Technical Service Bulletin: tsb100164

Released Date: 23-May-2002

HX82 High Pressure Turbocharger Improvement

Fig 1, New Design Turbocharger Housing. Note the casting change at the exhaust mounting flange.

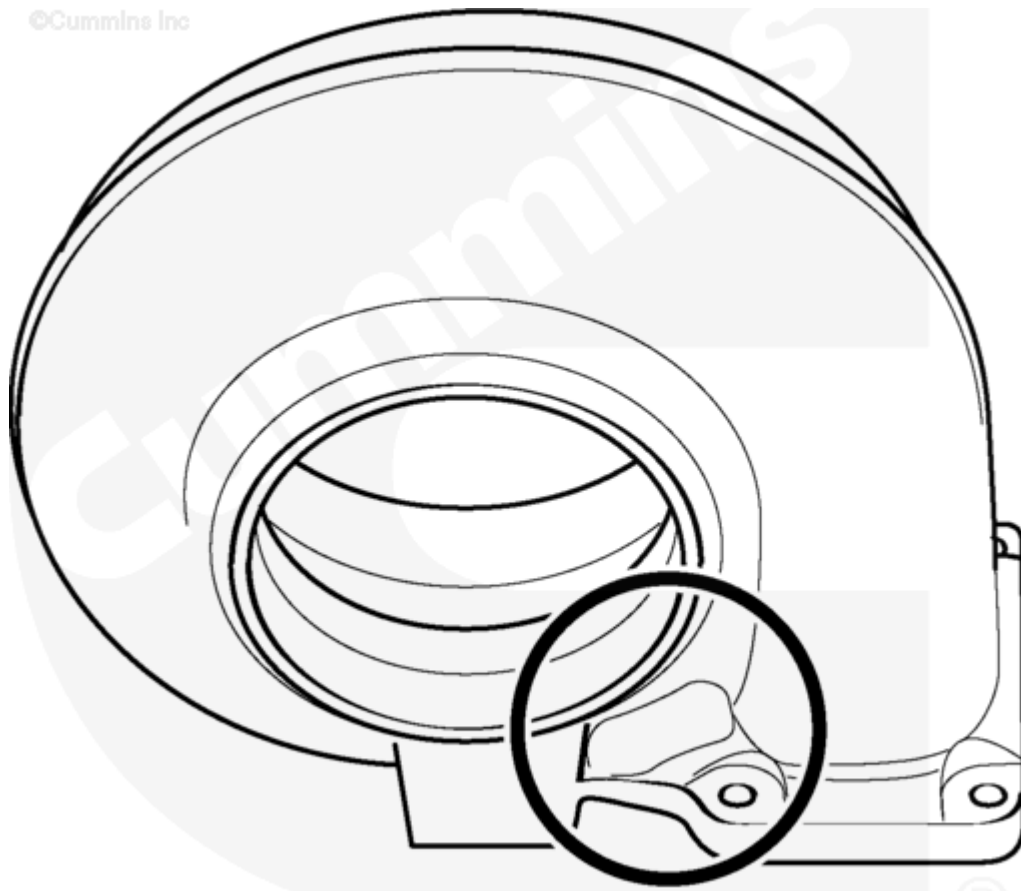
This Technical Service Bulletin announces the release of a new HX82 turbocharger service kit, Part Number 4089126. The turbocharger has a new turbine housing, designed to eliminate cracking at the exhaust mounting flange due to thermal fatigue.

Note : When replacing the turbine housing, the capscrews, lockplates and exhaust flange gasket must be changed. These parts must be ordered in addition to the turbine housing.
